威海宁威塑胶制品有限公司

TITLE: TA800UXE 5P

000-071012-030

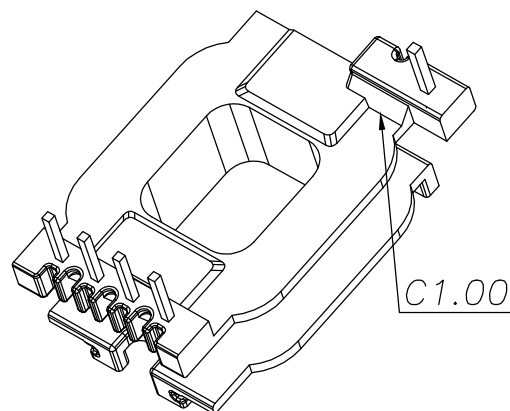
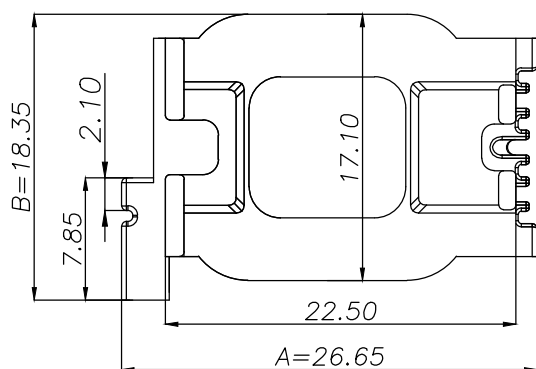
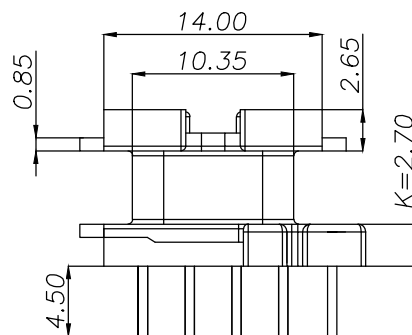
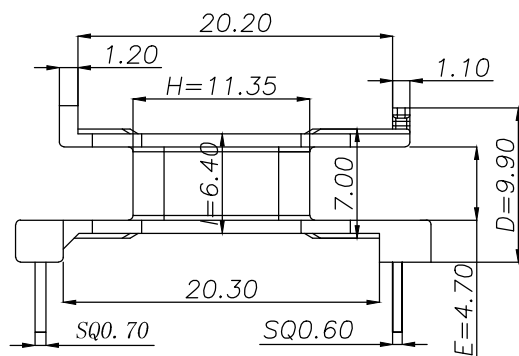
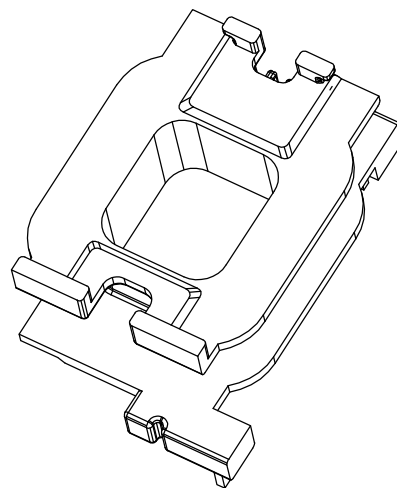
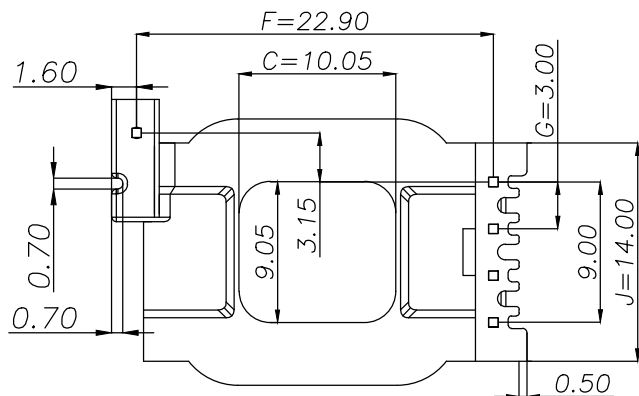
3.					
2020.06.29	1. PIN座由2. 50变更为2. 70mm。				
2020.04.14	1. 5PIN, PIN针由SQ0. 60变更为SQ0. 70。 2. 5PIN PIN座增加C1. 0角。				
REVISION NOTE					
DRAWN	CHECKED	APPROVED	MATERIAL: PHENOL	UL REC. : UL94V-0	
			X=PIN LENGHT	DATE: 2020.02.11
